# CITY OF ALBUQUERQUE

**RE: Juan Tabo Business Park Subdivision  
Conceptual Grading & Drainage Plans  
Engineer's Stamp Date: 04/26/23  
Hydrology File: G21D021**

Based upon the information provided in your submittal received 04/27/2023, the Conceptual Grading & Drainage Plans are preliminary approved for action by the Development Hearing Officer (DHO) on Preliminary/Final Plat.

JUAN TABO BUSINESS PARK ALBUQUERQUE, NM	DRAWN BY JL
	CONCEPTUAL GRADING AND DRAINAGE	DATE 04-26-2023
	TERRA WEST, LLC 5571 MIDWAY PARK PL NE ALBUQUERQUE, NEW MEXICO 87109 (505) 858-3100 www.tierrawestllc.com	DRAWING
		SHEET # GR-1
		JOB # 2022122

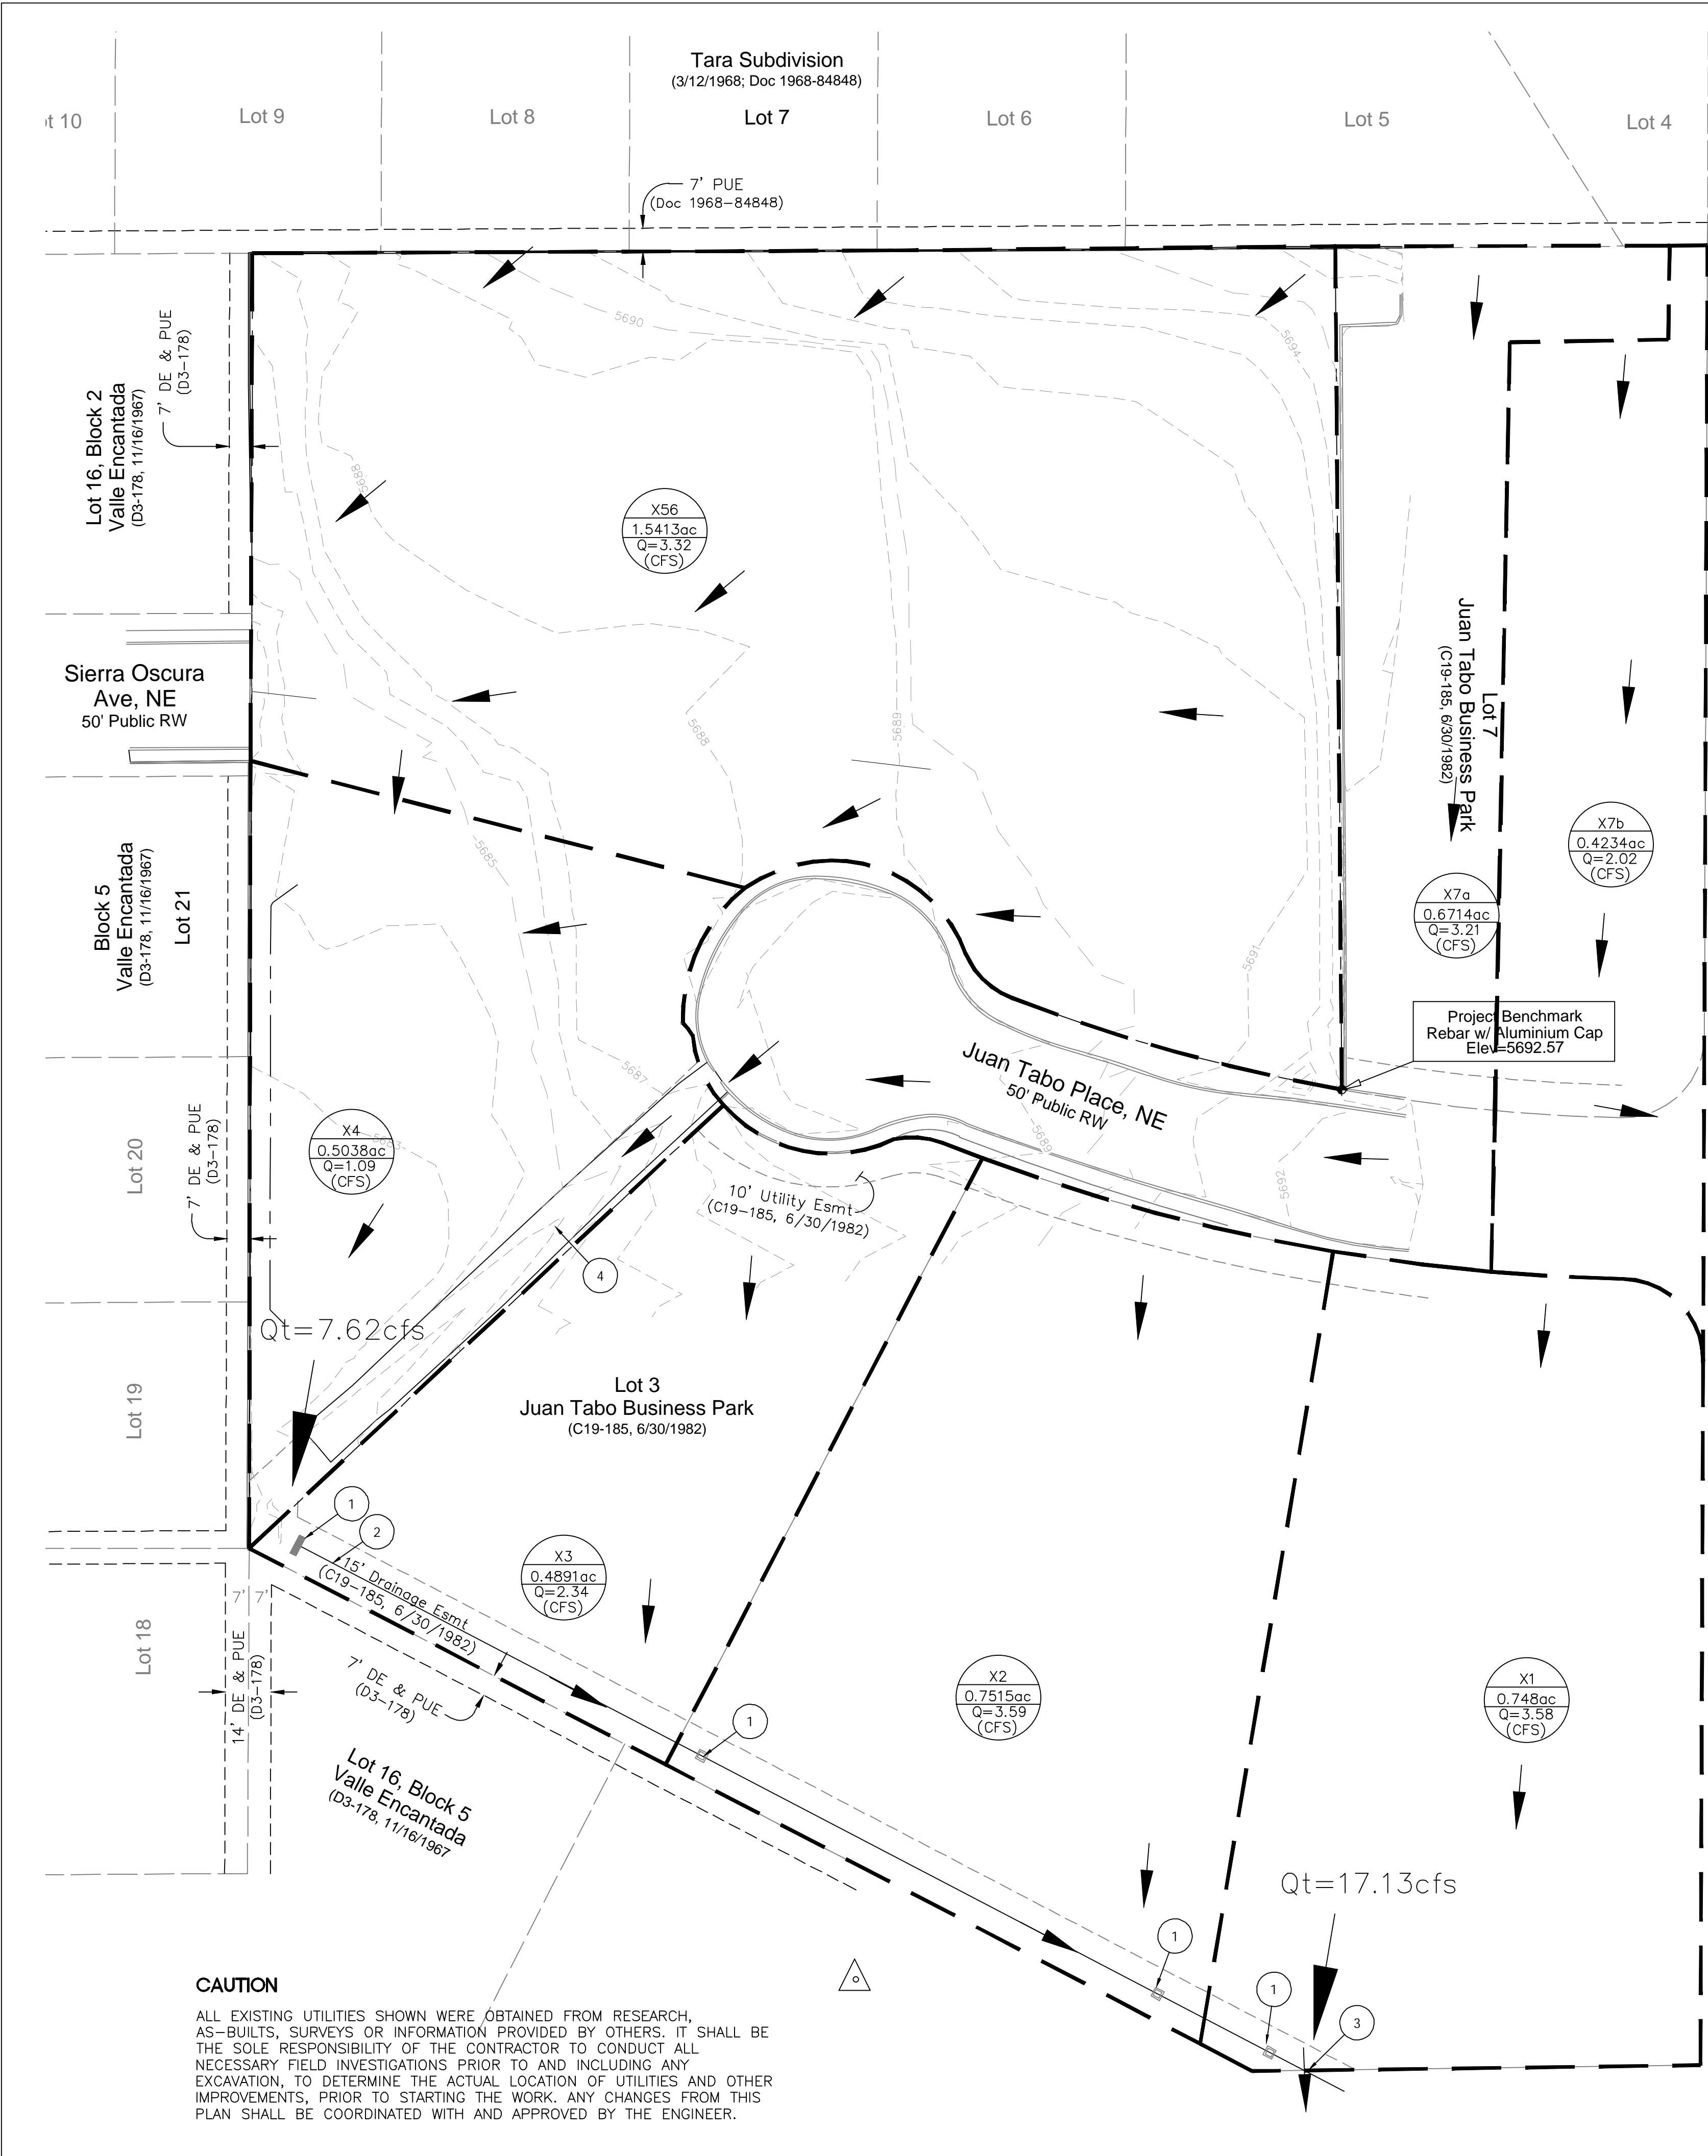
City of Albuquerque  
Planning Department  
Development Review Services  
**HYDROLOGY SECTION**  
**PRELIMINARY APPROVED**  
DATE: 05/30/23  
BY: *Renee C. Bruneau*  
HydroTrans # G21D021  
THESE PLANS AND/OR REPORT ARE CONCEPTUAL ONLY. MORE INFORMATION MAY BE NEEDED IN THEM AND SUBMITTED TO HYDROLOGY FOR BUILDING PERMIT APPROVAL.

SHEET #  
DR-2

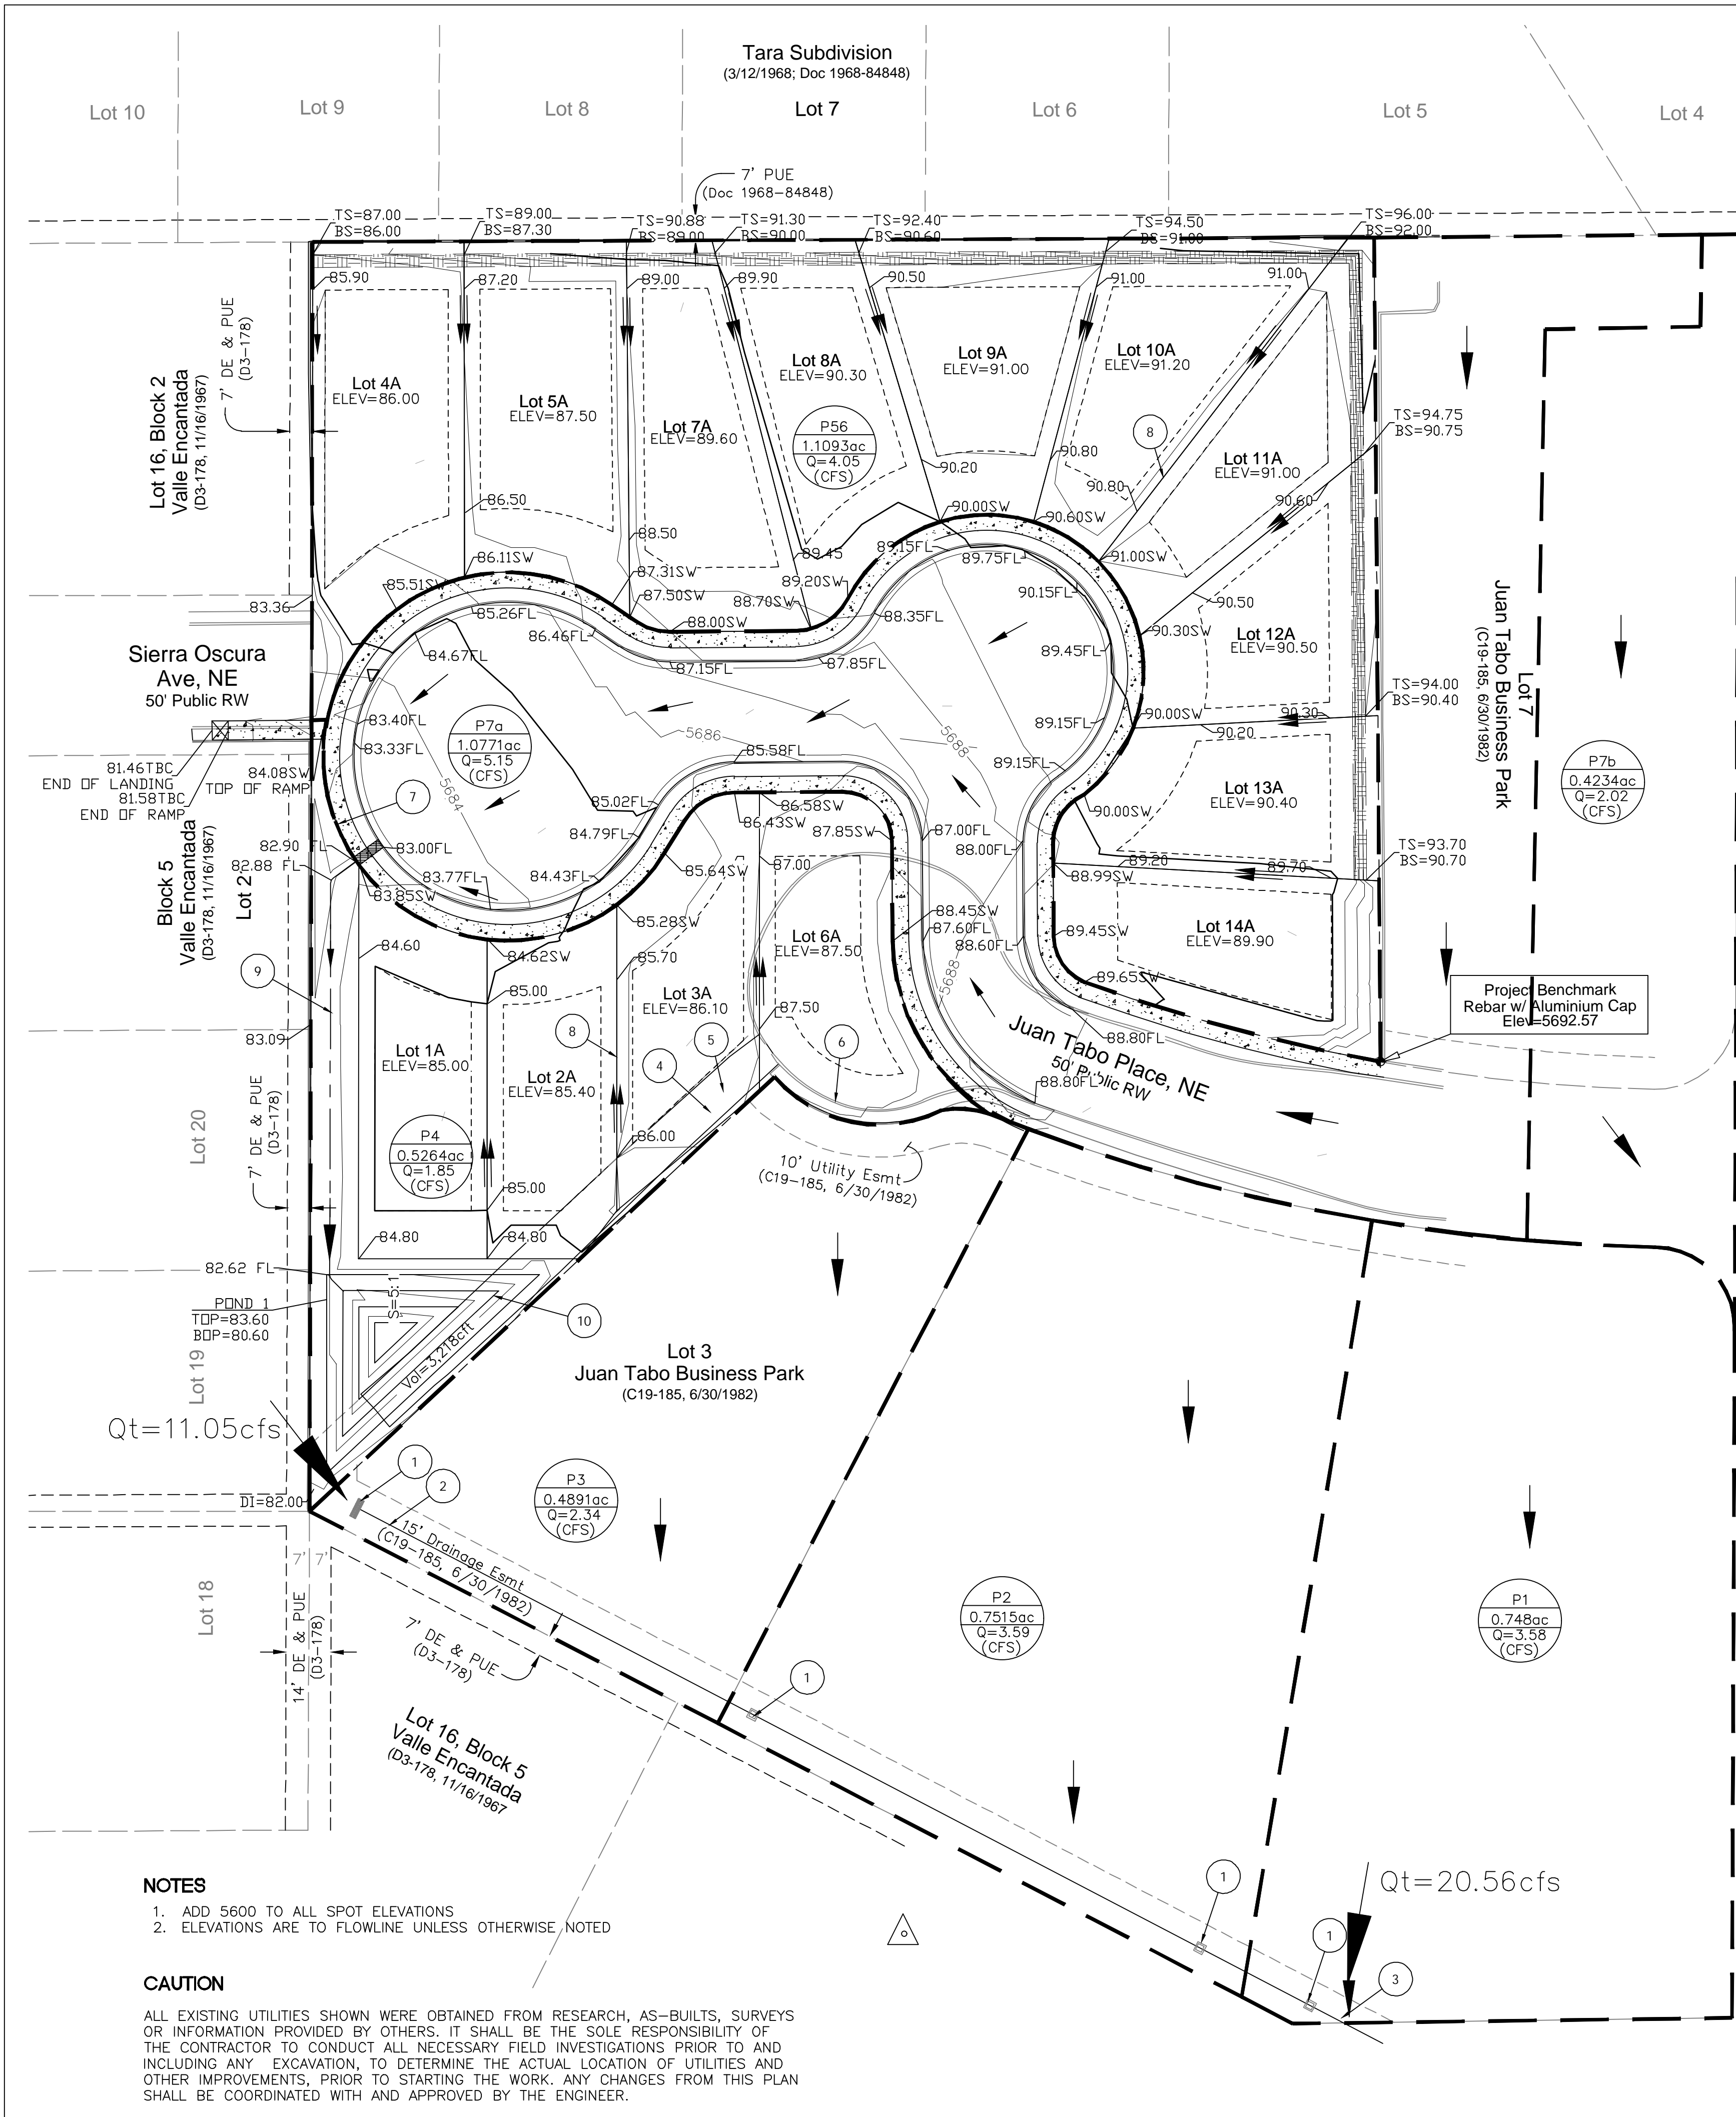
City of Albuquerque  
Planning Department  
Development Review Services  
**PRELIMINARY APPROVED**  
DATE: 5/30/23  
BY: *Renee Brissett*  
HydroTrans # G21D021

THESE PLANS AND/OR REPORT ARE CONCEPTUAL ONLY. MORE INFORMATION MAY BE NEEDED IN THEM AND SUBMITTED TO HYDROLOGY FOR BUILDING PERMIT APPROVAL.
